REGIONAL REVIEW FINDING

ARC REVIEW CODE: R1806191

Name of Proposal: Project Rocket (DRI 2807)

PROJECT ROCKET DRI 2807
Gwinnett County
ARC Natural Resources Group Comments
June 15, 2018

DRI PLAN

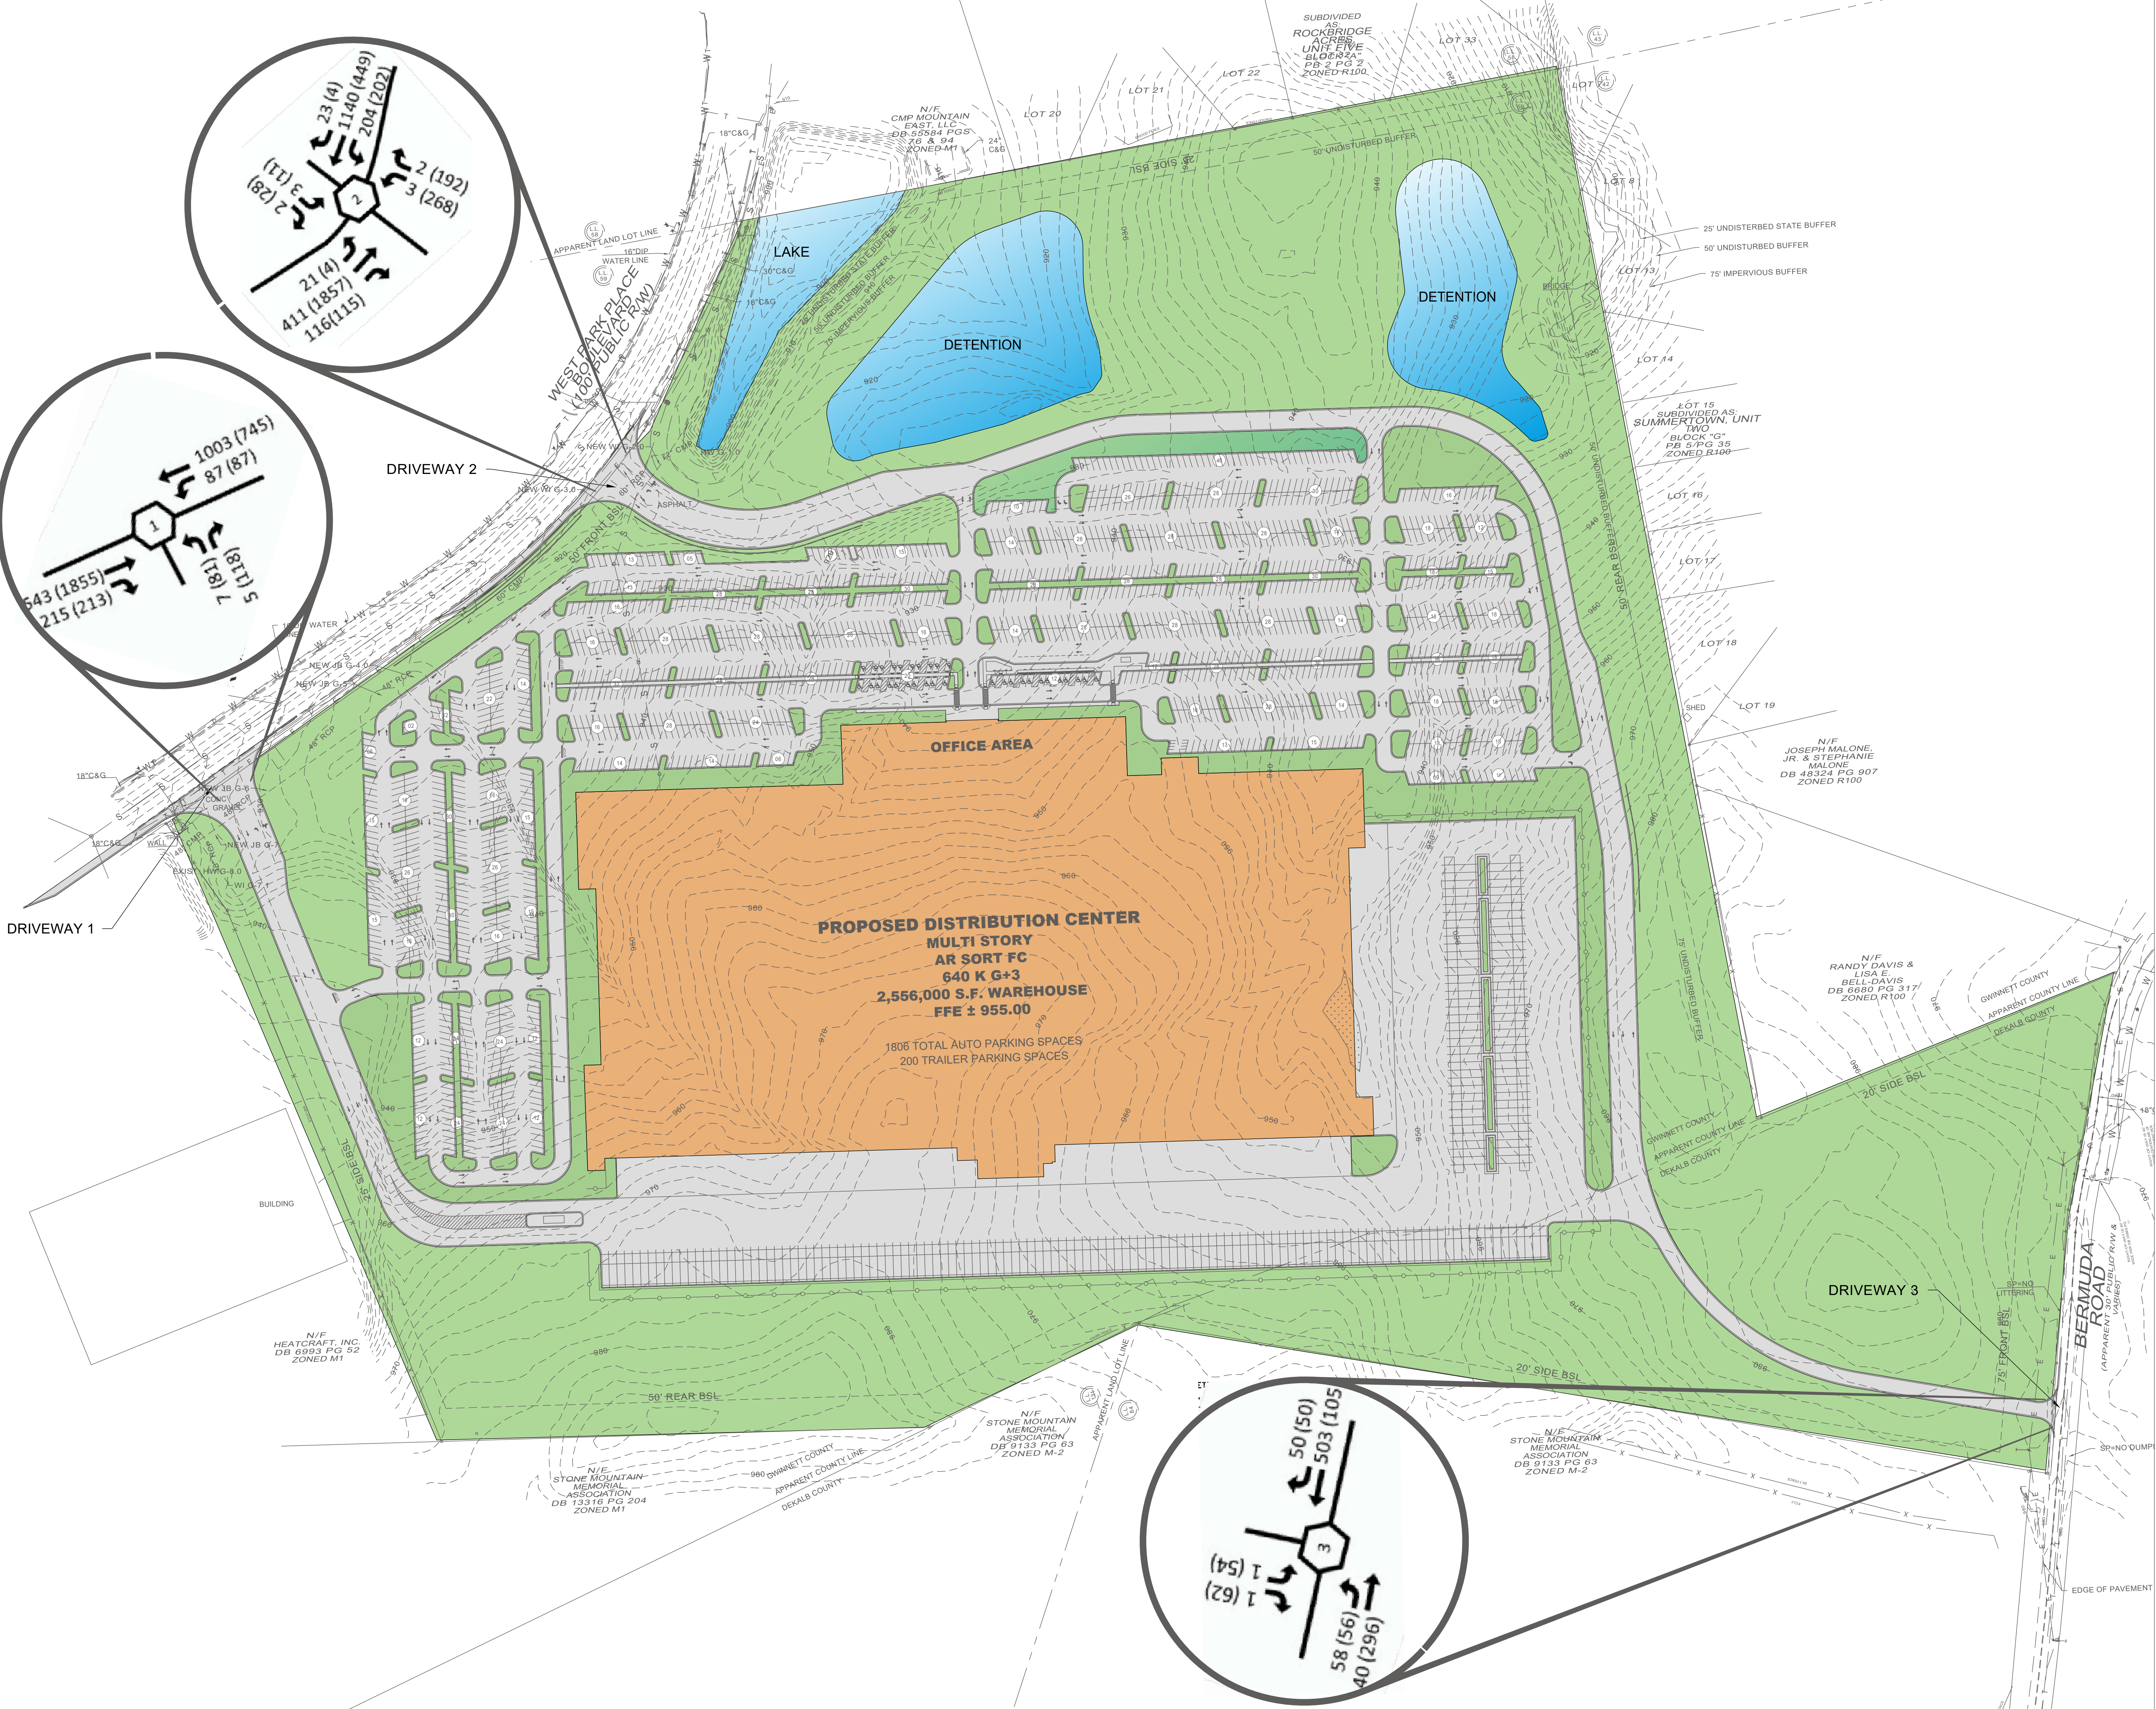
The development proposes industrial uses adjacent to undeveloped property designated for residential and industrial uses. The development does not propose stub outs for connectivity with adjacent parcels, however, connections may be made through local roads.

The development proposes sidewalks and pedestrian facilities along Bermuda Road and West Park Place Road adjacent to the site. Due to the nature of the use of the development, limited sidewalks are proposed.

The site plan depicts sidewalks along both Bermuda Road and West Park Place Road adjacent to the site. No bicycle facilities or internal pedestrian connections are proposed.
